Subject: Domtar Paper Company Landfill No. 3
Permit to Construct (PTC) Phase 3 and Phase 4 – Variance Request
NC DENR DIN 10869

Attachment 1
Sheet 7 of 10
(Revised September 2010)

PROJECT NAME: LANDFILL No. 3 - PHASE 1A & 1B CLOSURE DOMTAR PAPER COMPANY, LLC PLYMOUTH, NORTH CAROLINA

SHEET TITLE: DETAILS

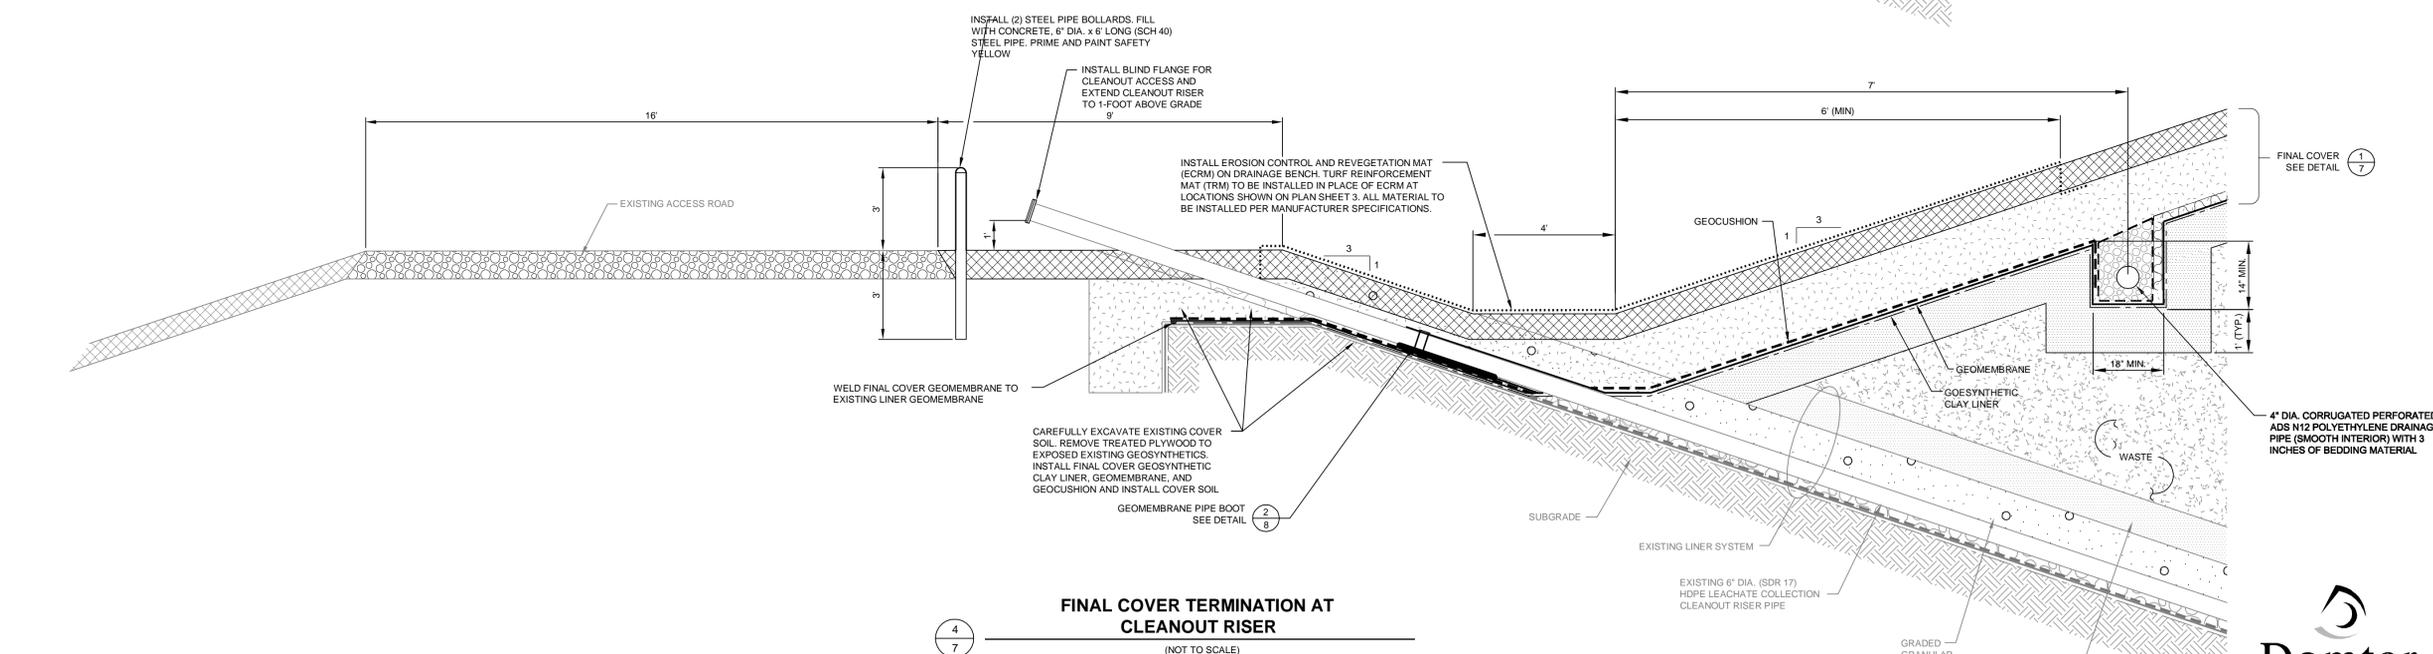
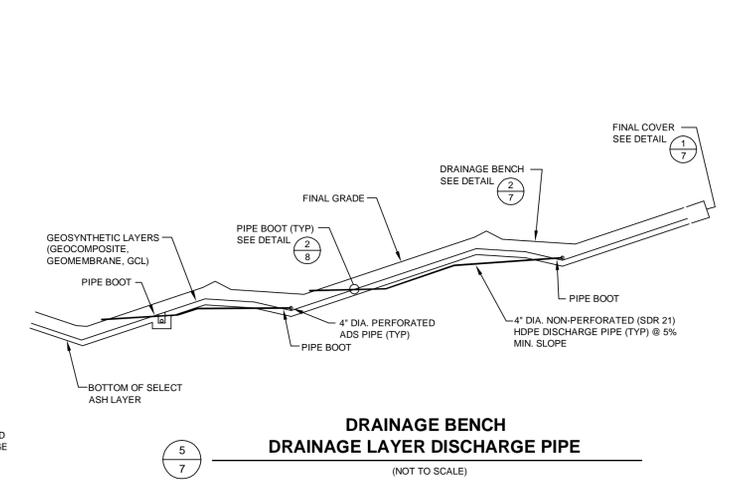
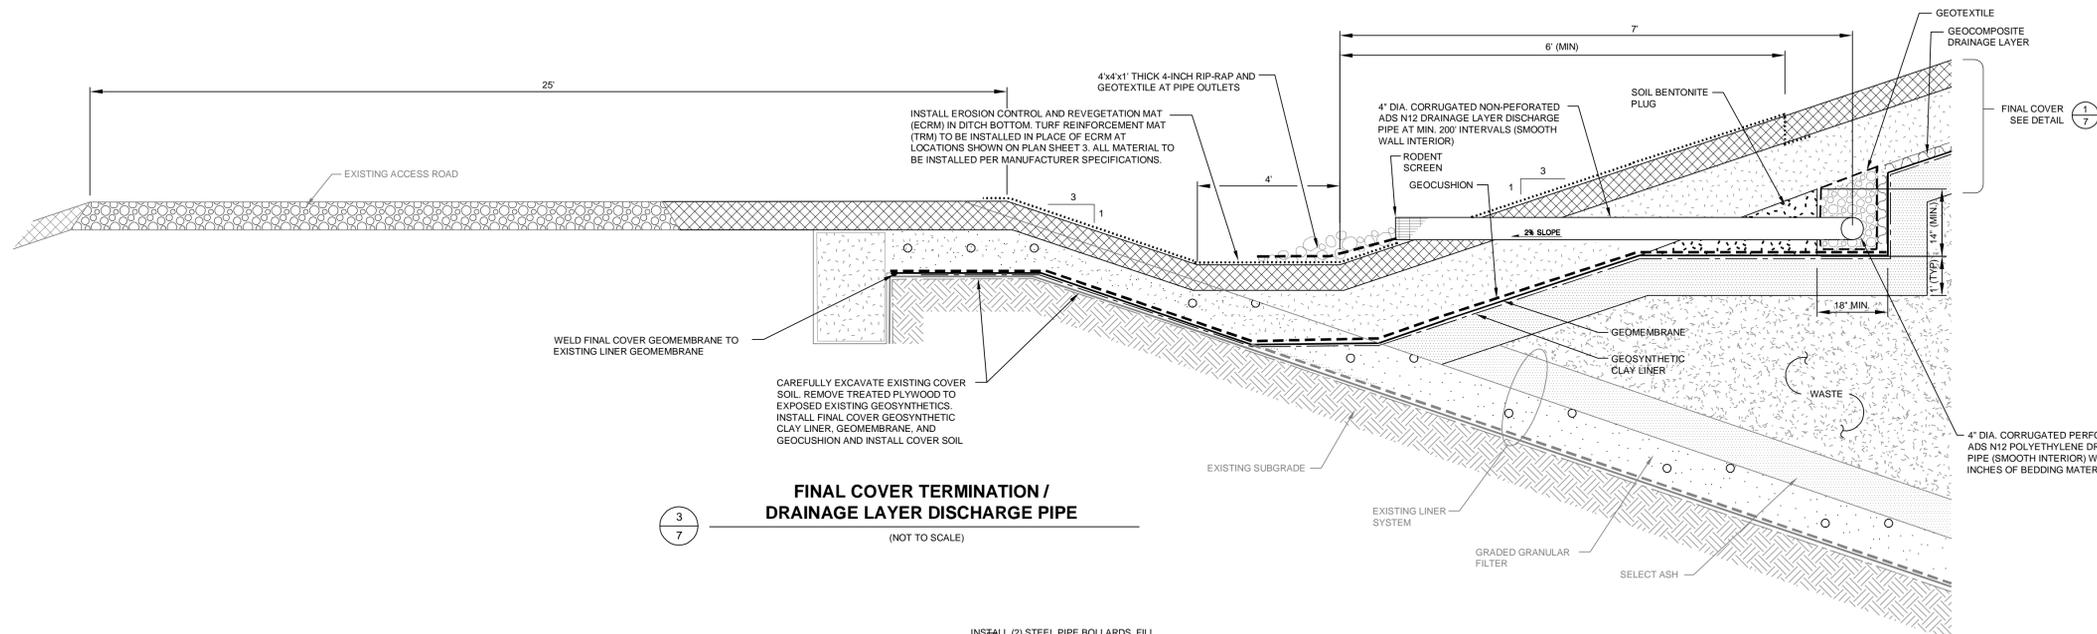
Please find the revised design drawing Sheet 7 of 10 from the Permit to Construct (PTC) Phase 3 and Phase 4 application attached to this document. Details 2 of 7 and 5 of 7 have been revised to reflect the design change to the drainage bench discharge pipe trench.

NO.	BY	DATE	REVISION	TWM	APP'D.
3					
2					
1	RBN	SEPT. 13, 2010	REVISED DETAIL 2 OF 7	TWM

NOTE: INSTALL 4" DIA. NON-PERFORATED (SDR 21) HDPE PIPE FROM DRAINAGE BENCH LOW POINTS TO DRAINAGE BENCH DITCH BELOW. MAINTAIN 5% MINIMUM PIPE SLOPE. REFER TO PLAN SHEET 5 FOR LOCATIONS. INSTALL PIPE BOOTS AND SOIL BENTONITE PLUGS AT LINER PENETRATIONS PER DETAIL 2 ON PLAN SHEET 8.
